Supporting Material – TQM Related Comments (259, 260) for 800GBASE-LR1, 800GBASE-ER1-20, 800GBASE-ER1

**IEEE P802.3dj Task Force
IEEE 802.3 September 2024 Interim
Hamburg, Germany**

Introduction

Calibrated Coherent Detector Front-End

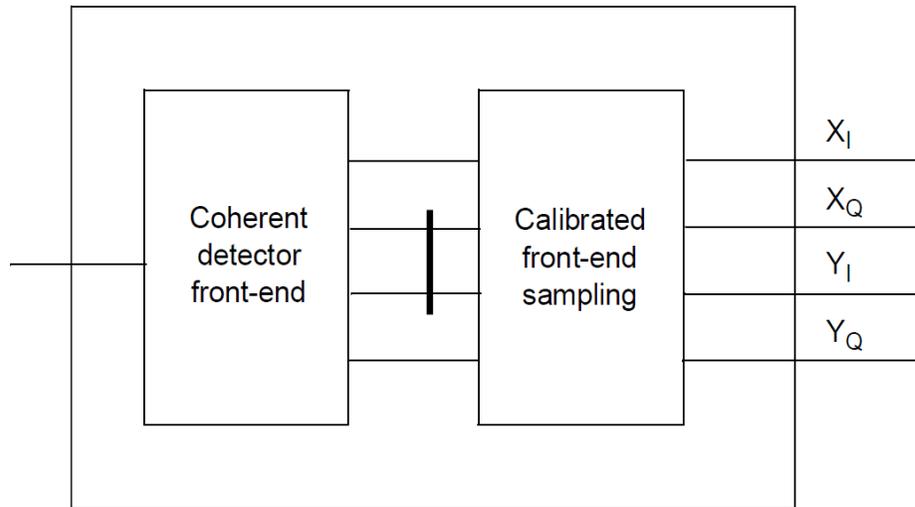
- Add proposed table consisting of parameter values for post calibration residuals

Description	Value	Unit
X-Y gain error (max)	0.2	dB
X-Y skew (max)	0.5	ps
I-Q phase error for X (max)	2	degree
I-Q gain error for X (max)	0.2	dB
I-Q skew for X (max)	0.2	ps
I-Q DC offset for X (max)	-26	dB
I-Q instantaneous offset for X (max)	-20	dB
I-Q phase error for Y (max)	2	degree
I-Q gain error for Y (max)	0.2	dB
I-Q skew for Y (max)	0.2	ps
I-Q DC offset for Y (max)	-26	dB
I-Q instantaneous offset for Y (max)	-20	dB
Bandwidth mismatch [X,Y:I,Q] (max)	1	GHz
Carrier frequency offset (max)	0.1	GHz

- Add subclauses providing definitions of noted parameters

Coherent Detector Front-end

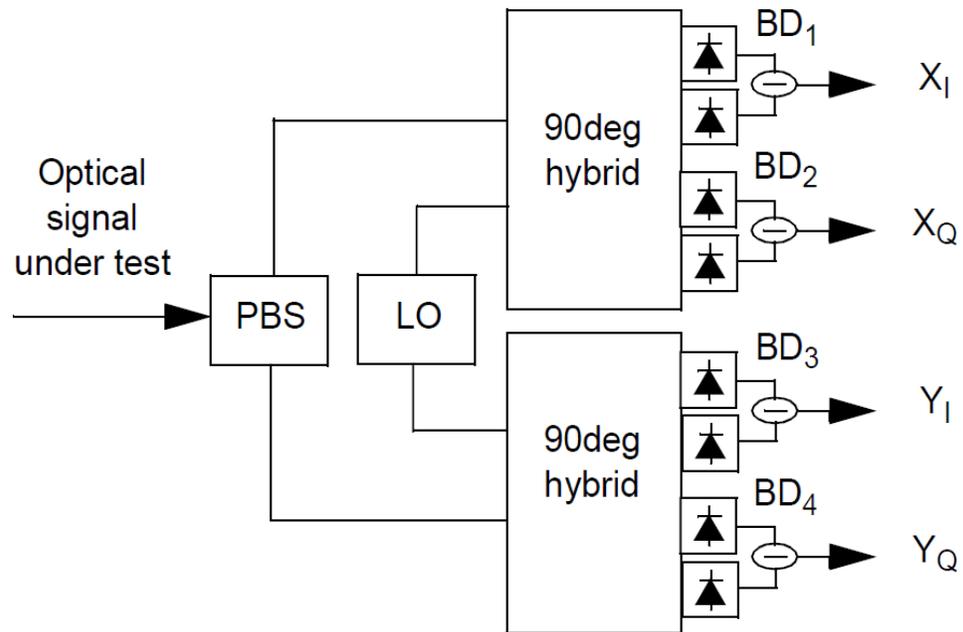
Add text:

The incoming optical signal is split into two orthogonal polarizations (x and y) by a polarization beam splitter (PBS). The two polarization components are mixed with their co-polarized components from the optical local oscillator (LO) in two 90-degree optical hybrids, followed by four balanced photo-detectors (BD_x), which convert the four components of the optical signals into their corresponding electric signals.

Add Table: Coherent detector front-end parameters

Description	Value	Unit
3-dB bandwidth (min)	65	GHz
ENOB	5	bit
Oversampling ratio	1.25	
Local oscillator linewidth (max)	30	kHz

Add subclauses providing definitions of noted parameters

Offline digital signal processing used for TQM calculation

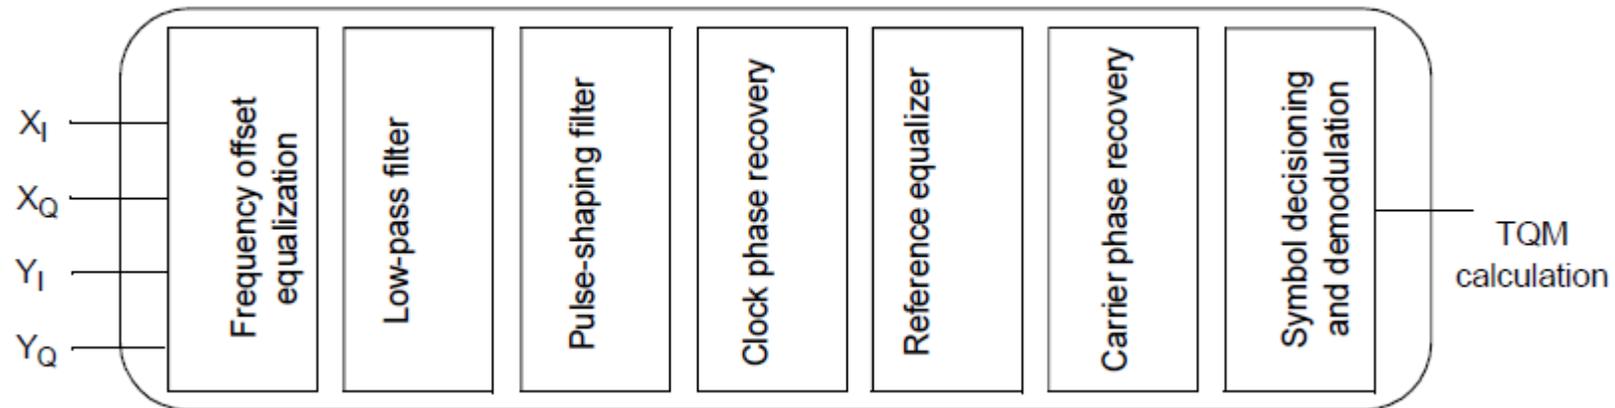
- Add subclauses providing definitions of noted steps. Leverage descriptions for each step on Page 7 of fan_3dj_02a_2407.pdf.
